**UNITED STATES
NUCLEAR REGULATORY COMMISSION
ADVISORY COMMITTEE ON REACTOR SAFEGUARDS
WASHINGTON, DC 20555 - 0001**

October 22, 2009

SUBJECT: CLOSURE OF STEAM GENERATOR ACTION PLAN ITEMS 3.1k, 3.4, 3.5, 3.10, 3.11, and 3.12

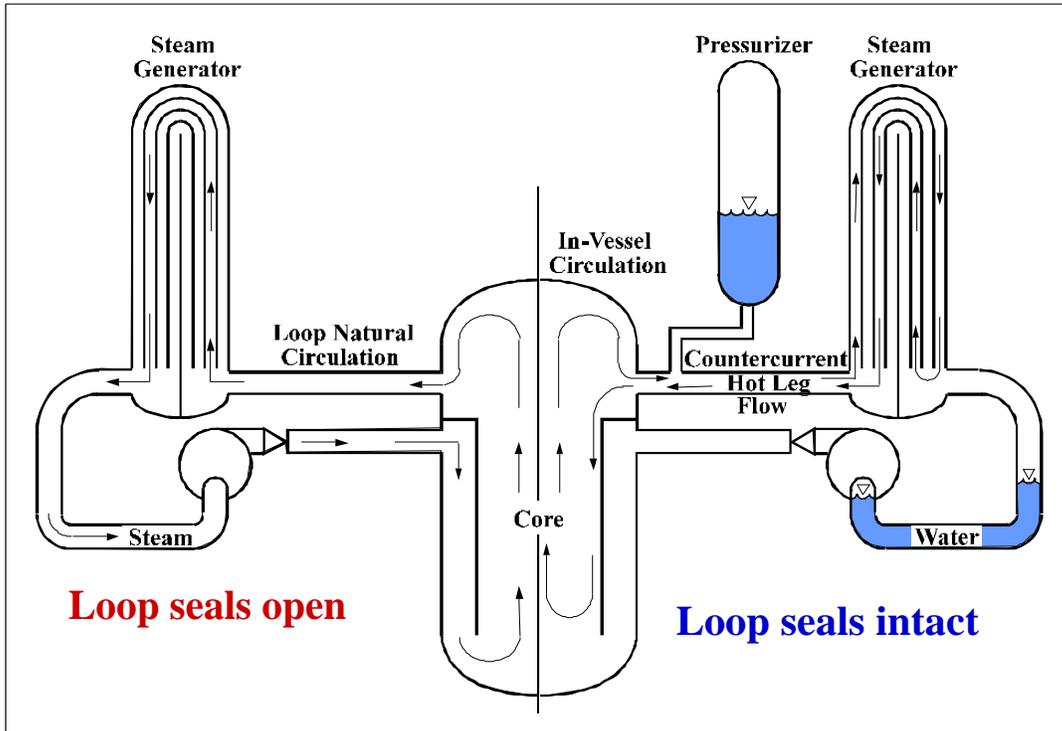
The threat to tube integrity during the progression of a core meltdown accident arises from the natural convection of hot steam and hydrogen from the core region to the steam generators. Two limiting patterns for such natural convection are depicted schematically in Figure 1. On the left of this figure, the loop seals are open and full convective flow through the tubes can occur. On the right, loop seals are shown to be intact. A very complicated countercurrent flow of gas through the hot leg and the steam generator develops in this case. The concern for both possible natural convection patterns is that heat loads placed on the tubes by convection currents could be sufficient that tubes will fail by creep rupture.

Convection currents that develop when the loop seals are open impose the highest heat loads on the steam generator tubes and under these conditions failure is likely. Opening of the loop seals is a complicated issue that depends very much on specific design features of the reactor coolant system. We have not reviewed capability of existing accident analysis computer codes to predict the clearing of loop seals during accident progression.

For many plants, it is thought more likely that loop seals will remain intact for much of the core damage progression. Heat loads imparted to the steam generator tubes in the case of countercurrent natural circulation are mitigated by the mixing in the lower plenum of the steam generator of hot gases coming from the core region with cooler gases in the return flow.
